# 87C196KT 20 MHz–Automotive

Specification Update

*November 1998*

Order Number: [272863-004](#)

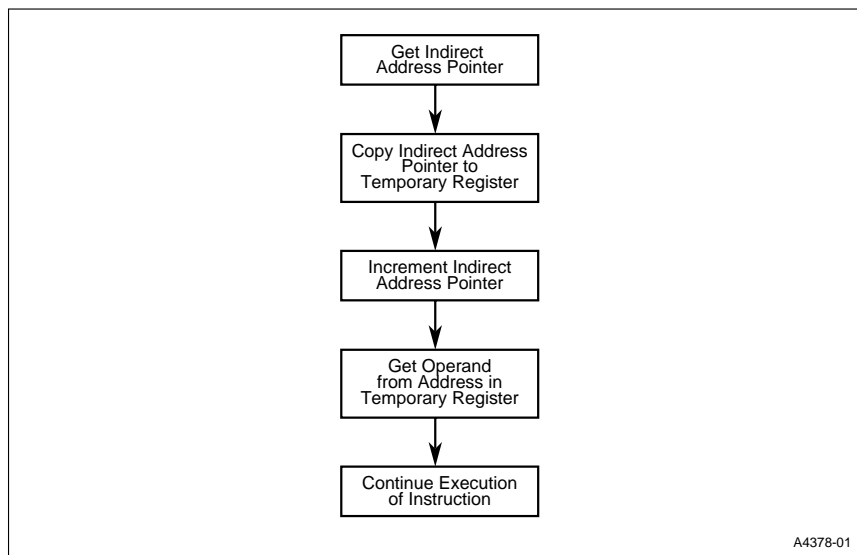
**Problem:** The EPA can lock up if overruns are handled incorrectly. Overruns occur when an EPA input transitions at a rate that cannot be handled by the EPA interrupt service routine. If no overrun handling strategy is in place, and if the following three conditions exist, a situation may occur where both the capture buffer and the EPAX\_TIME register contain data, and no EPA interrupt pending bit is set:

- an input signal with a frequency high enough to cause overruns is present on an enabled EPA pin, and
- the overwrite bit is set (EPAX\_CON.0 = 1; old data is overwritten on overrun), and
- the EPAX\_TIME register is read at the exact instant that the EPA recognizes the captured edge as valid.

The input frequency at which this occurs depends on the length of the interrupt service routine as well as other factors. Unless the interrupt service routine includes a check for overruns, this situation will remain the same until the device is reset or the EPAX\_TIME register is read. The act of reading EPAX\_TIME allows the buffered time value to be moved into EPAX\_TIME.

This clears the buffer and allows another event to be captured. Remember that the act of transferring the buffer contents to the EPAX\_TIME register is what actually sets the EPAX interrupt pending bit and generates the interrupt.

**Workaround:** Any one of the following methods can be used to prevent or recover from an EPA overrun situation.

- Clear EPAX\_CON.0  
When the overwrite bit (EPAX\_CON.0) is zero and both the EPAX\_TIME register than the buffer are full, the EPA does not consider a captured edge until the EPAX\_TIME register is read and the data in the capture buffer is transferred to EPAX\_TIME. This prevents overruns by ignoring new input capture events when both the capture buffer and EPAX\_TIME contain valid capture times. The OVRx pending bit in EPA\_PEND is set to indicate that an overrun occurred.

- Enable the OVRx interrupt and read the EPAX\_TIME register within the ISR  
If an overrun occurs, the overrun (OVRx) interrupt will be generated. The OVRx interrupt will then be acknowledged and its interrupt service routine will read the EPAX\_TIME register. After the CPU reads the EPAX\_TIME register, the buffered data moves from the buffer to the EPAX\_TIME register. This sets the EPA interrupt pending bit.

- Check for pending EPAX interrupts before exiting an EPAX ISR  
Another method for avoiding this situation is to check for pending EPA interrupts before exiting the EPA interrupt service routine. This is an easy way to detect overruns and additional interrupts. It can also save loop time by eliminating the latency necessary to service the pending interrupt. However, this method cannot be used with the peripheral transaction server (PTS).

**Figure 1. 16-bit System with EPROM**

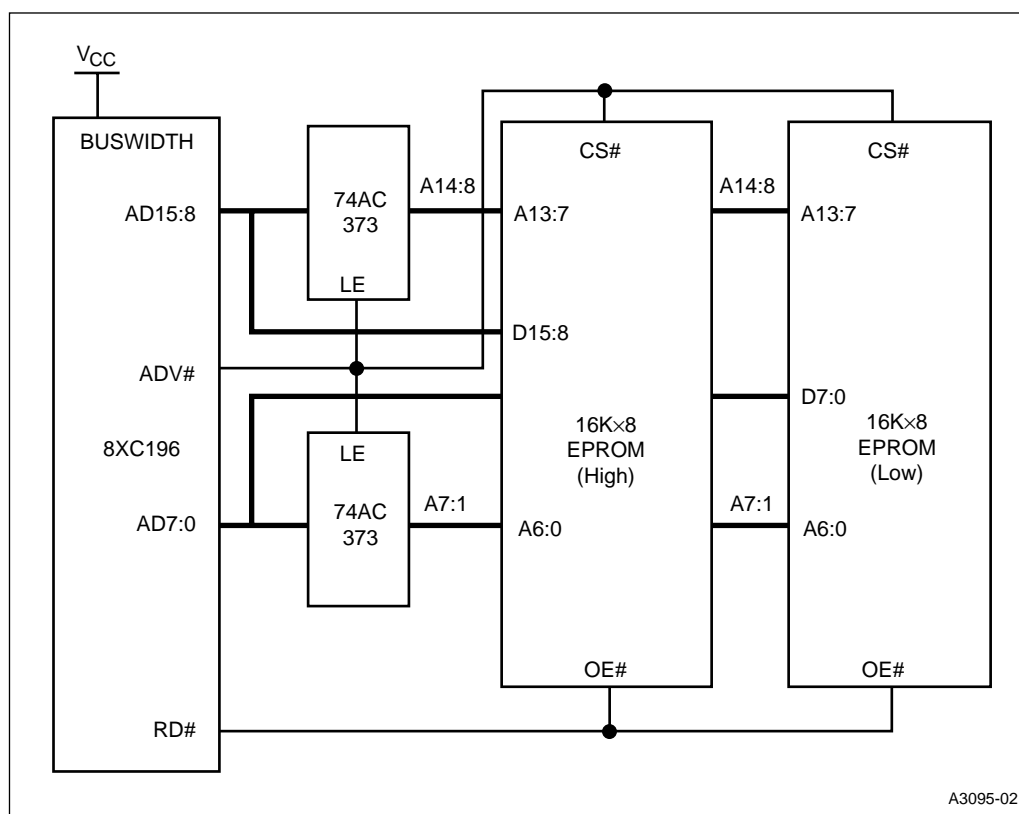
**Issue:** In the *87C196Kx, 8XC196Jx, 87C196CA Microcontroller Family User's Manual*, the block diagram for a 16-bit system with EPROM incorrectly listed the high address inputs to the low EPROM as A15:8. The correct inputs are A14:8, as reflected in the following figure:
